ADDENDUM NO. 2

DATE: December 19, 2024
FROM: City of Grand Junction Purchasing Division
TO: All Offerors
RE: Horizon Drive and G Road Roundabout IFB-5548-24-DD

REVISED ELECTRICAL DETAILS DRAWING PAGE 10 of 16

C TYPICAL UTILITY BOX DETAIL

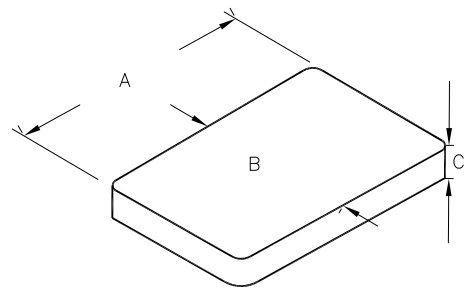
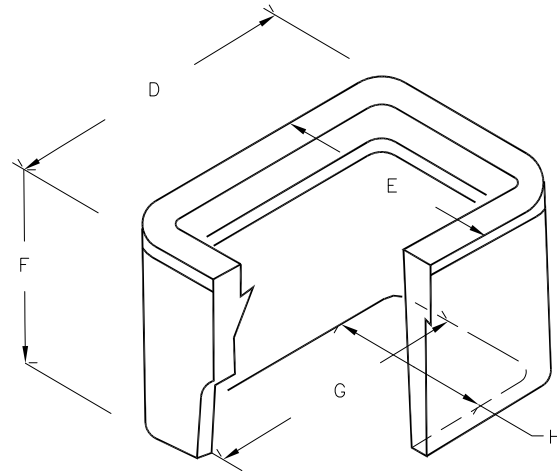
7. **Question:** Will engineer stamped drawings for 614-80003 RRFB poles or foundations be required on this project?
Answer: No
8. **Question:** Should Item 613-70003 Type 3 Pull Box be provided with dimensions listed in the electrical drawings on page 10 table as a Type 3, or should the Type 5 Pull Box dimension be provided as shown on Page 10 table and Page 11?

Answer: The Bid Schedule has been revised. A type 5 pull box, with dimensions on page "E11", shall be used for the fiber. And the type 2 dimensions on page "E10" for the electrical pull boxes.

- ELECTRIC PULL BOX WILL BE LABELED "ELECTRIC", FIBER PULLBOX WILL BE LABELED "GJ FIBER"
- ELECTRIC WILL BE TYPE 2 AND FIBER WILL BE TYPE 5, REFERENCE DRAWING E 11 DETAIL "MARTIN ENTERPRISES 3048 BROADBAND PULLBOX" FOR FIBER PULLBOX OF THIS DRAWING SET.
